Addendum / Addenda

Project Description / Description de projet M38 M38 Electrical Service		
Solicitation No./N° de sollicitation 17-22113	Project No./N° de projet 5310	W.O. No./N° d'ordre de travail A1-006442-01
Departmental Representative / représentant ministériel Allan Smith		Date January 15, 2018
Notice: This addendum shall form part of the tender documents and all conditions shall apply and be read in conjunction with the original plans and specifications.		Nota: Cet addenda fait partie intégrale des dossiers d'appel; toutes les conditions énoncées doivent être lues et appliquées en conjonction avec les plans et les devis originaux.

- 1 Included with this addendum are replacement drawings 5310-E01R, 5310-E02R, 5310-E03R to replace 5310-E01, 5310-E02 and 5310-E03.
- 2 A question was raised regarding the size of the transformer secondary wiring. It is to be 3 x (4 #350+GND RWU90). Cable spec as below:

drawing dessin
MANHOLE AND GROUNDING

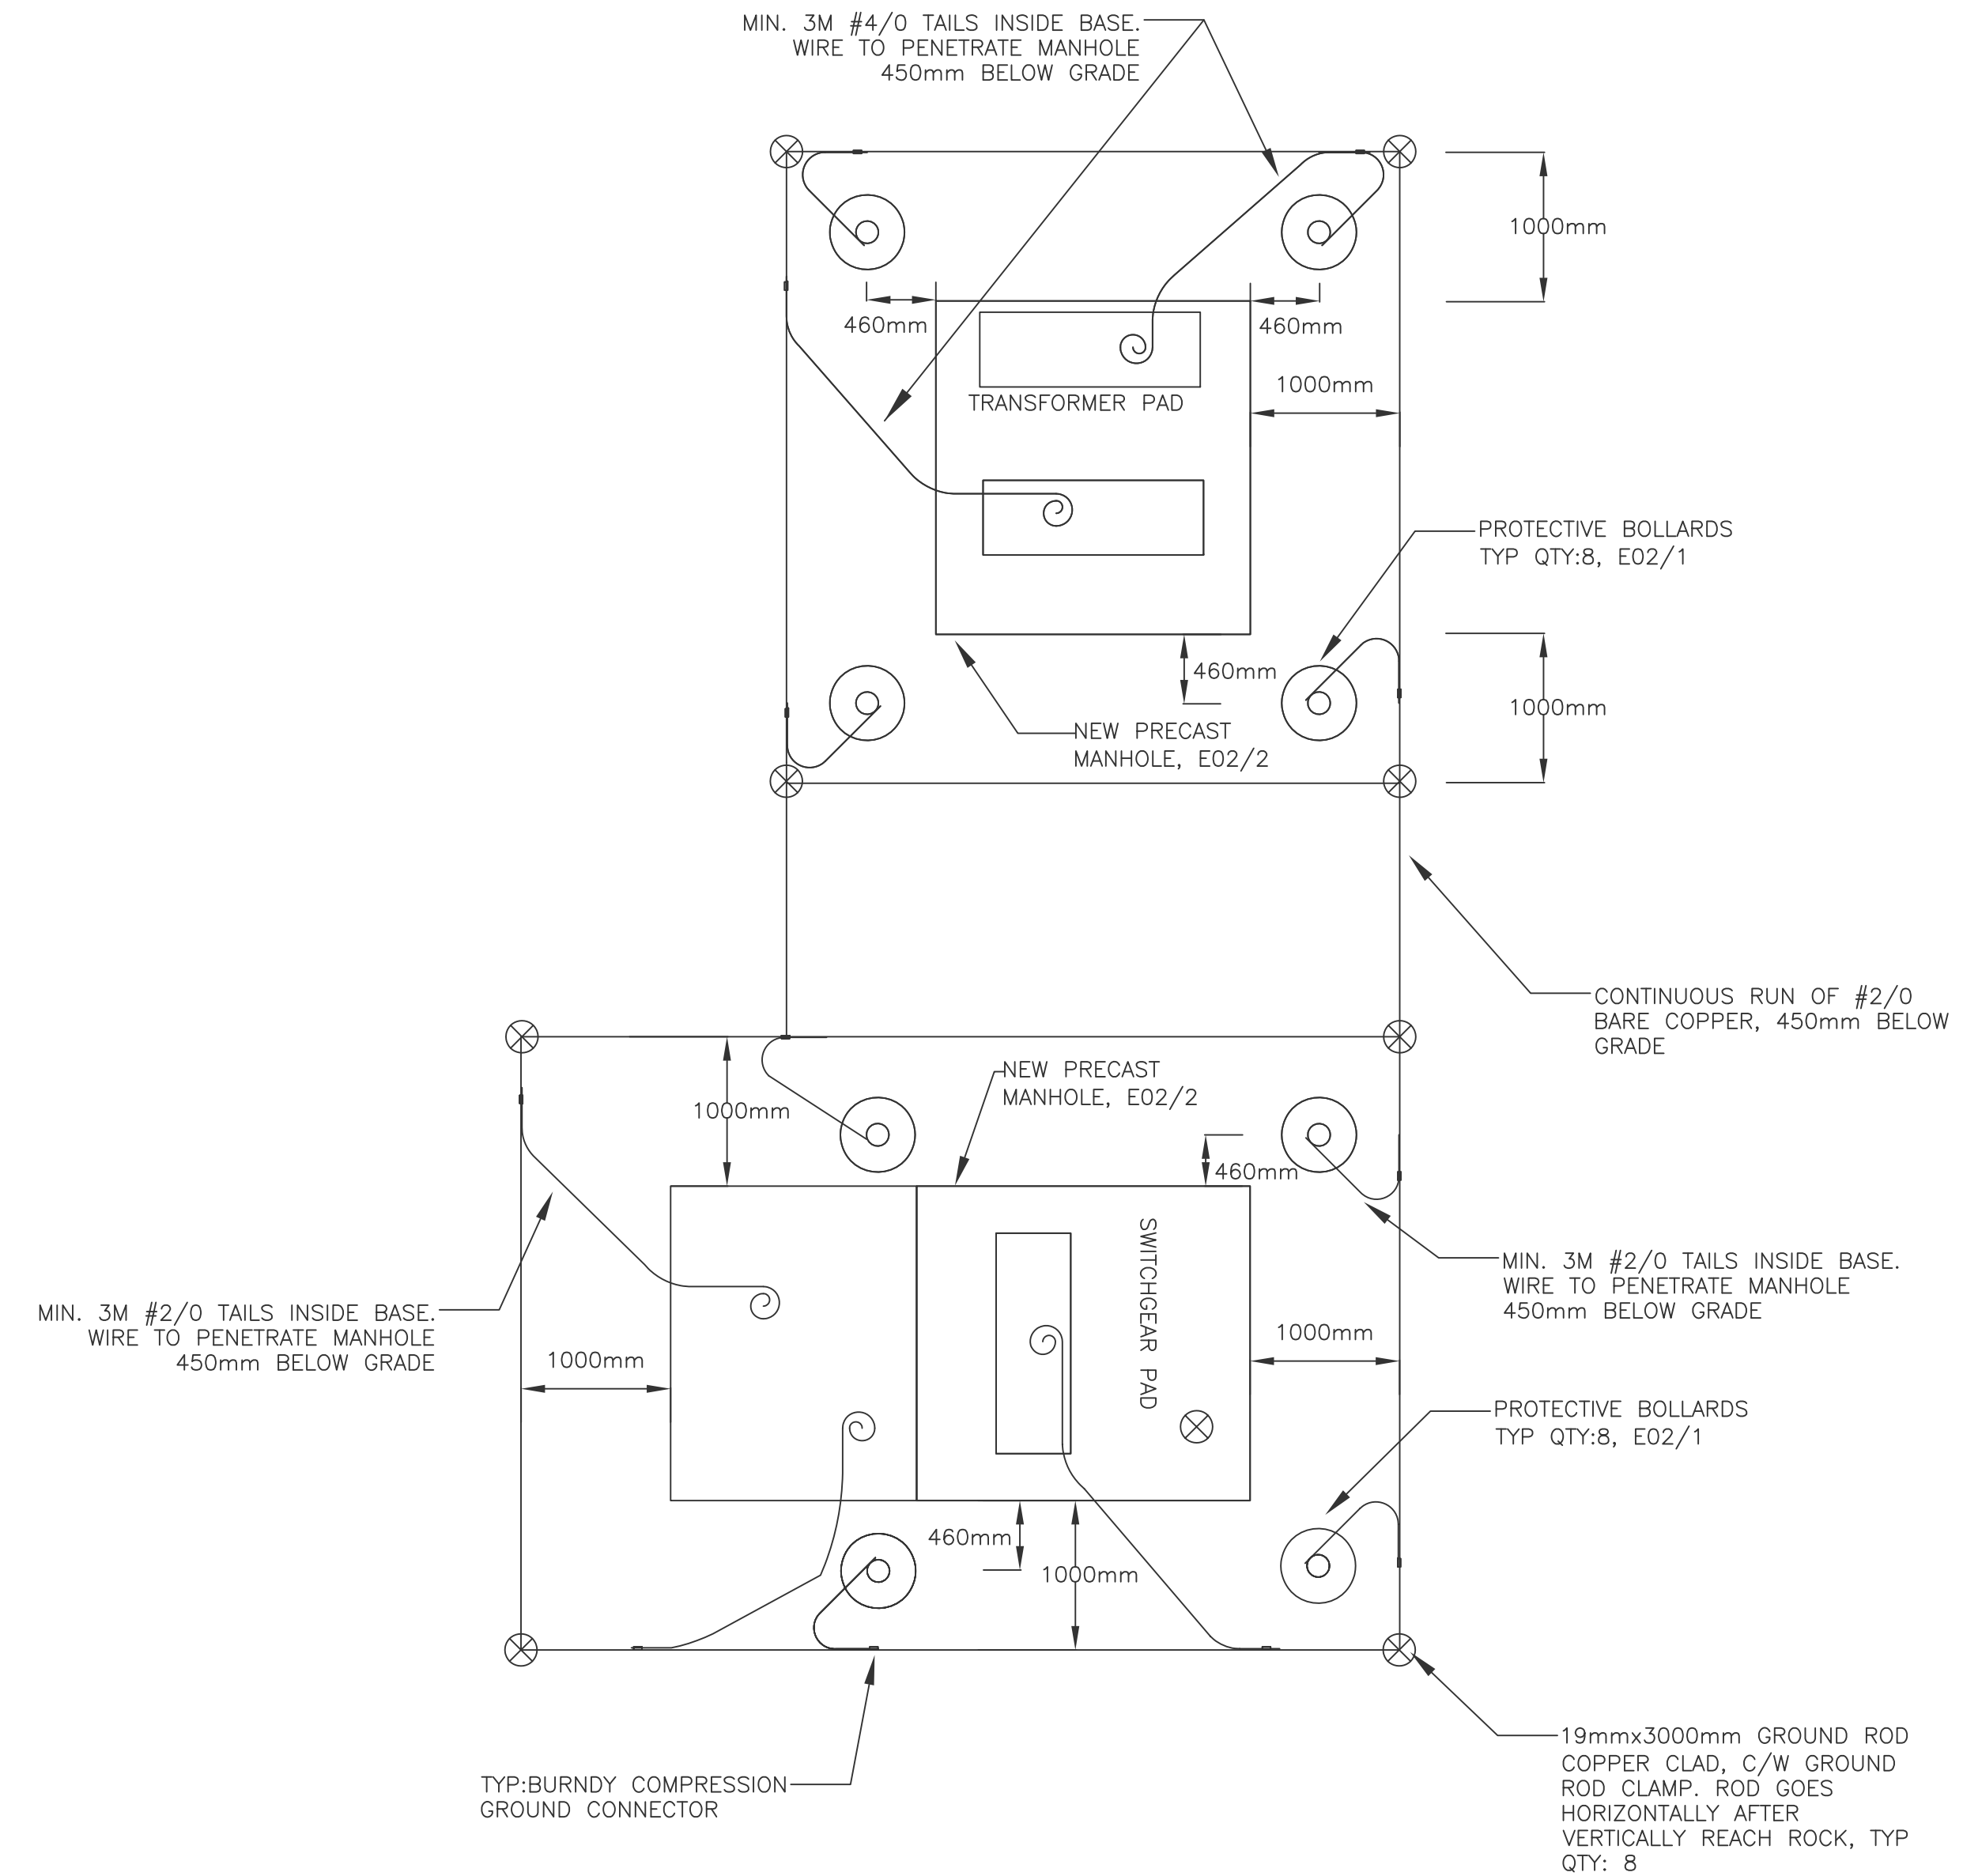
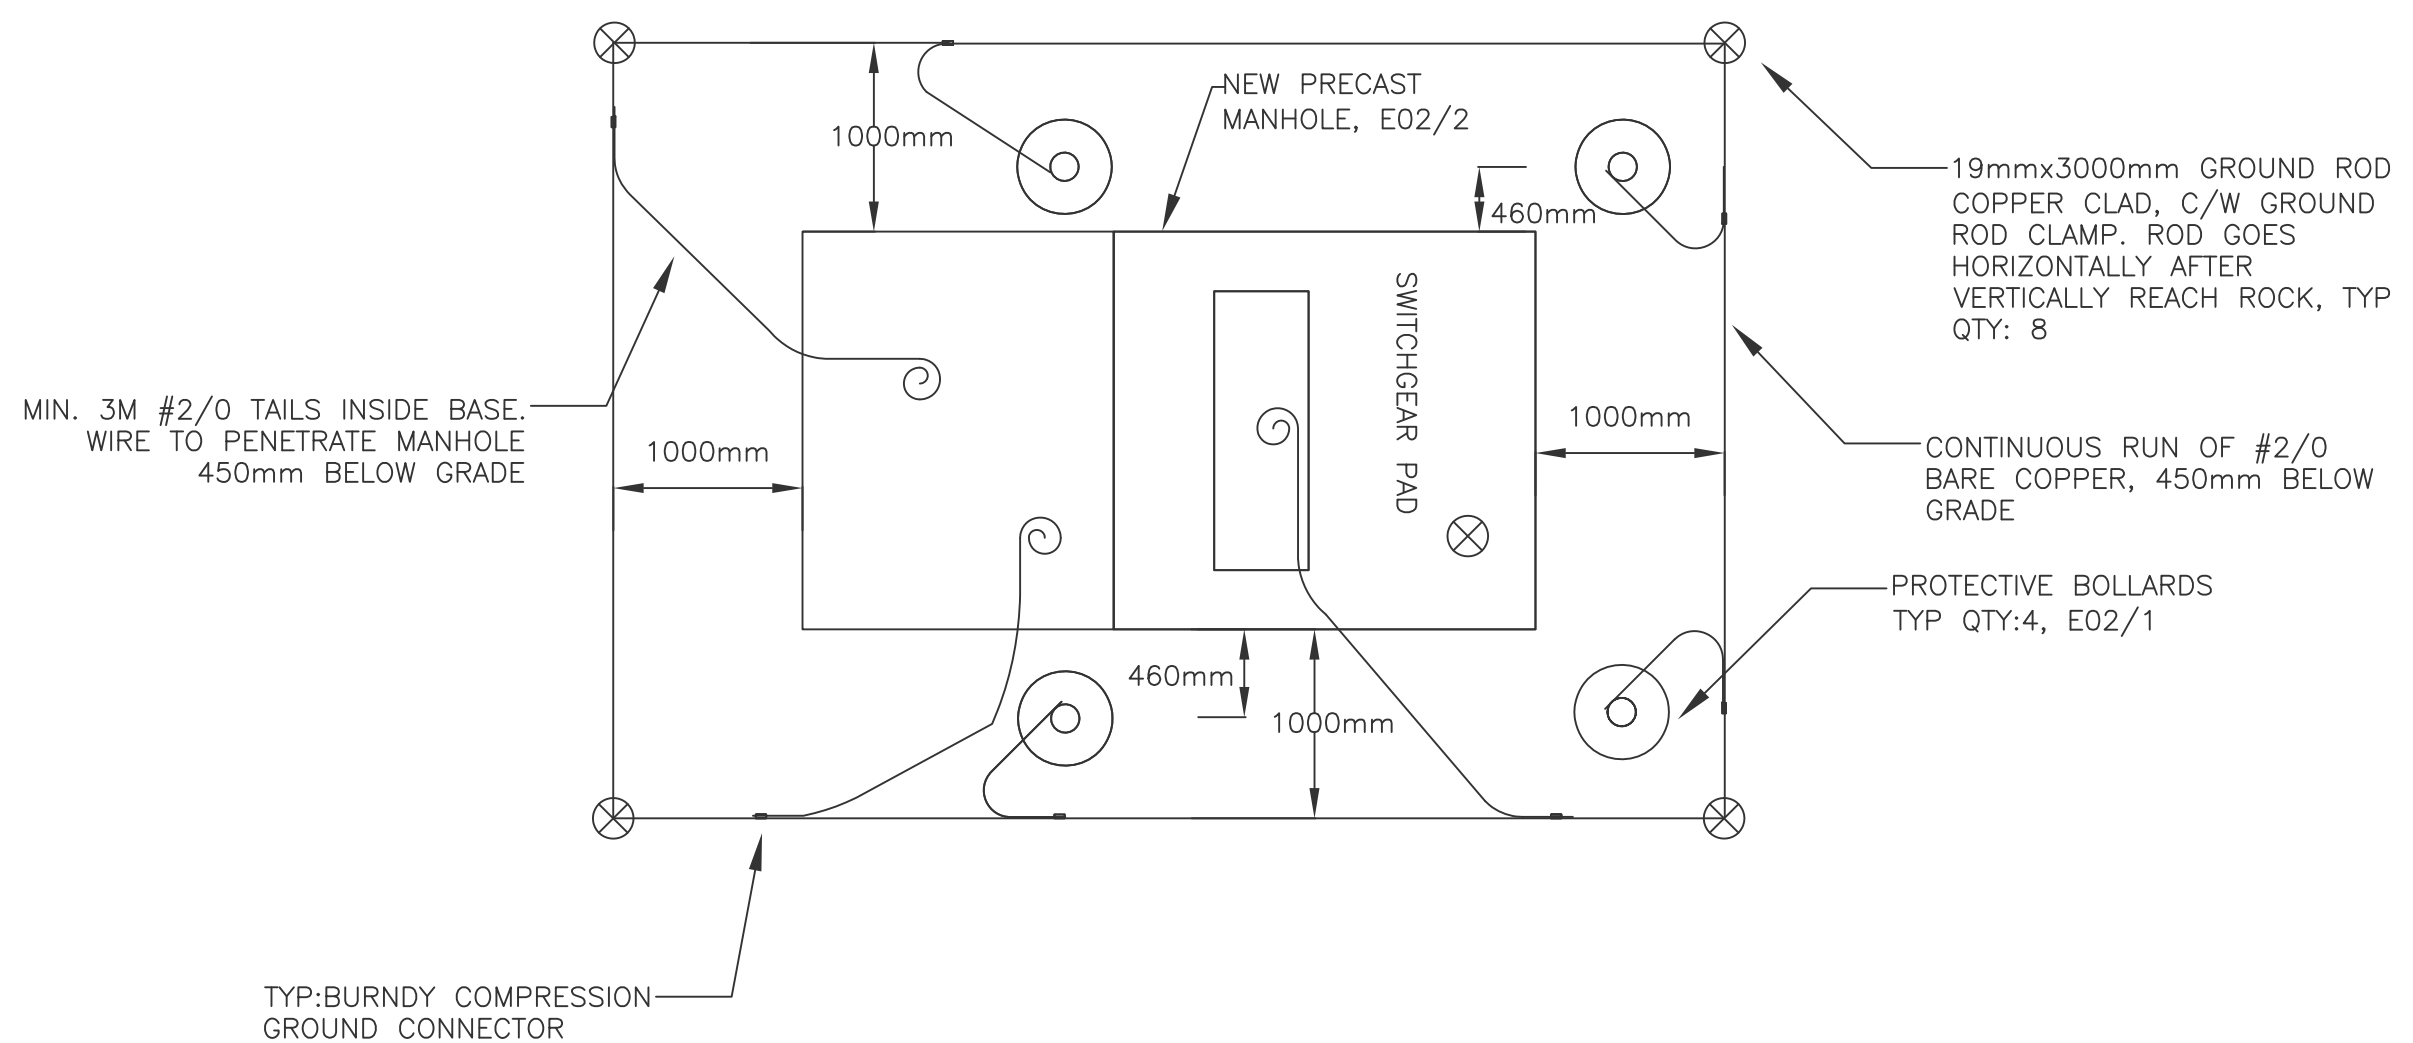
- 11 Drawing 5044-E02 is included for reference. This shows existing grounding system already in place. Contractor needs to connect new transformer to existing grounding system.
